# CITY OF ALBUQUERQUE

**RE: Marble Townhomes**  
**Grading Plan and Drainage Report**  
**Engineer's Stamp Date: 12/29/17**  
**Hydrology File: J18D046**

Based upon the information provided in your submittal received 01/02/2018, the Grading Plan **is not** approved for Building Permit and Grading Permit. The following comments need to be addressed for approval of the above referenced project:

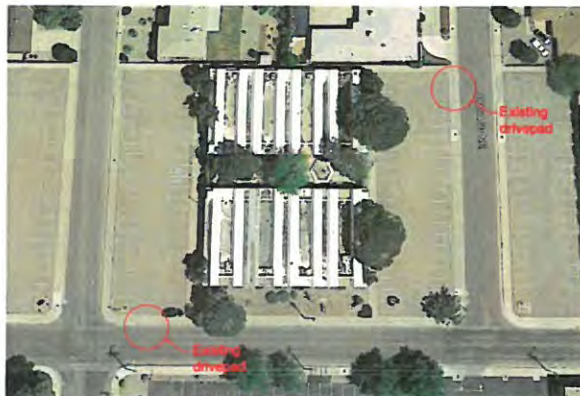
1. The site currently shows more than 1 acre of disturbance is being proposed. An Erosion and Sediment Control Plan is required and has to be submitted to the storm water quality engineer (Curtis Cherne, PE, [ccherne@cabq.gov](mailto:ccherne@cabq.gov)). Hydrology's approval for Grading or Building Permit will not be given until the submittal of the ESC Plans.
2. Please provide a note showing the first flush required volume and the first flush provided volume.
3. Please provide a typical detail for the turned CMU block. This block needs to be at least four (4) inches above the proposed grade to avoid clogging.
4. There are two missing remove drivepad & replace with curb & gutter note as outlined in the following photo.
